## TECHNICAL BULLETIN

[Issue No.] GOT-A-0111-A

[Title] Changes in Rating Plate of GOT and Optional Products

[Relevant Models] GOT2000 Series, GOT1000 Series

#### 1.1 Rating plate

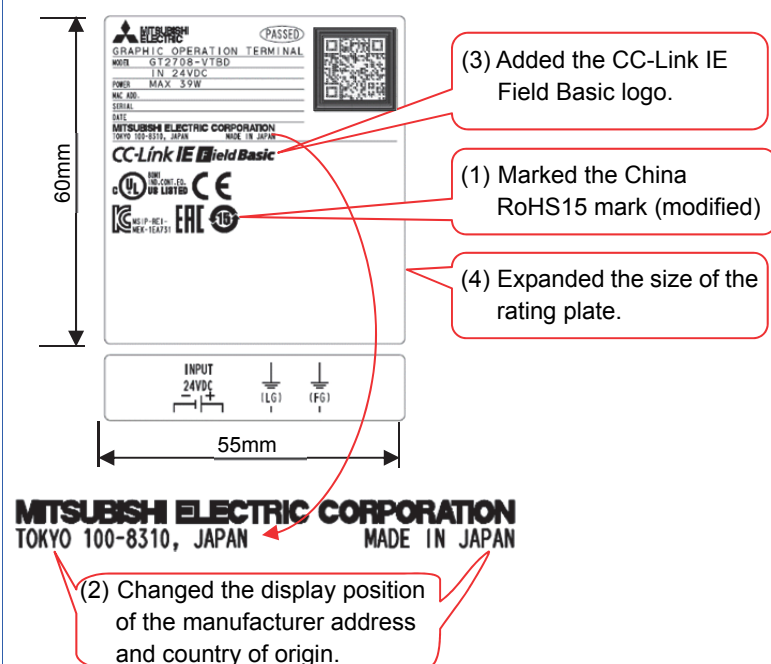
- (1) The marking method of the Environment-Friendly Use Period mark of China RoHS (modified) has been changed to rating plate from sticker.
- (2) The display position of the manufacturer address and country of origin has been changed.
- (3) The CC-Link IE Field Basic logo has been added to the rating plate of the GT27 and GT25 models.
- (4) The size of the GOT rating plate has been expanded for the GT27 and GT25 models with screen size of 15, 12.1, 10.4, or 8.4 inch.
- (5) The layout on the rating plate has been changed along with the above changes.

**1.2 Rear case of GT2708 and GT2508**

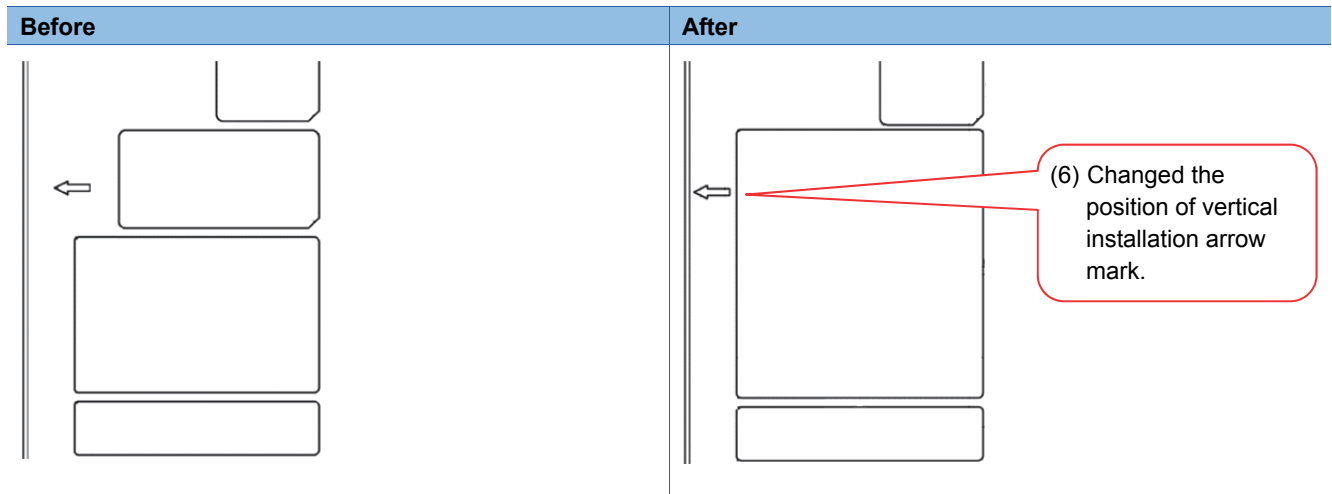
(6) The position of vertical installation arrow mark has been changed for GT2708 and GT2508 along with the change (4).

**1.3 Rear case of GT2104-RTBD, GT2104-PMBD and GT2103-PMBD**

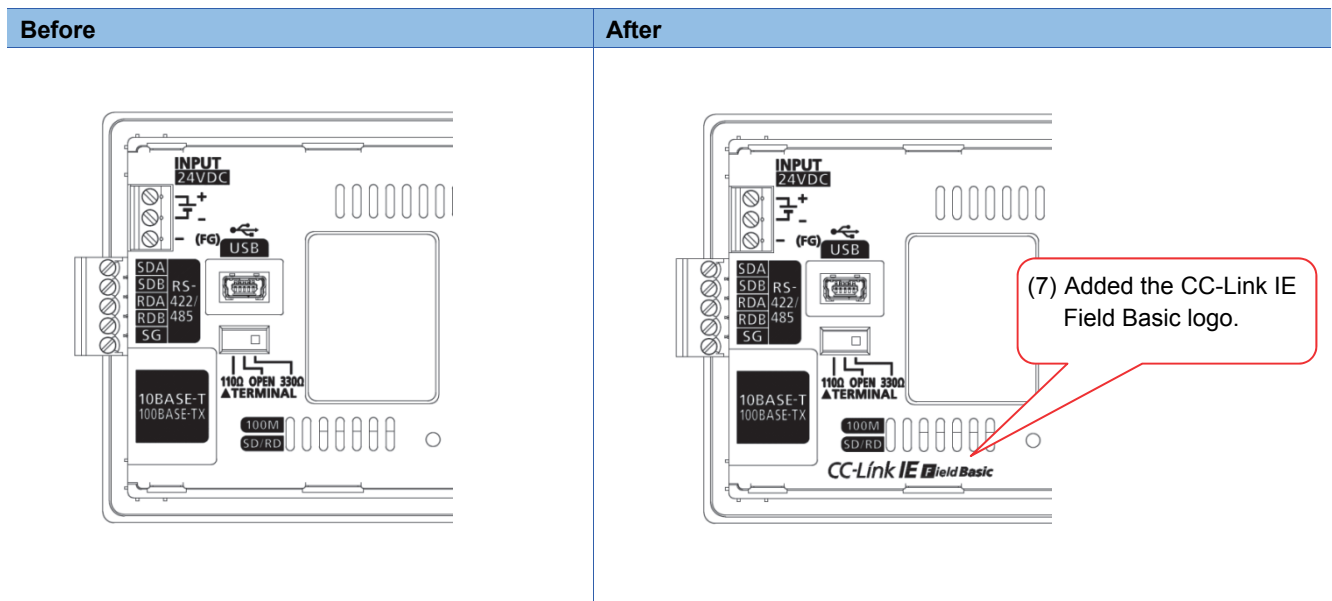
(7) The CC-Link IE Field Basic logo has been added to the rear case of GT2104-RTBD, GT2104-PMBD and GT2103-PMBD.
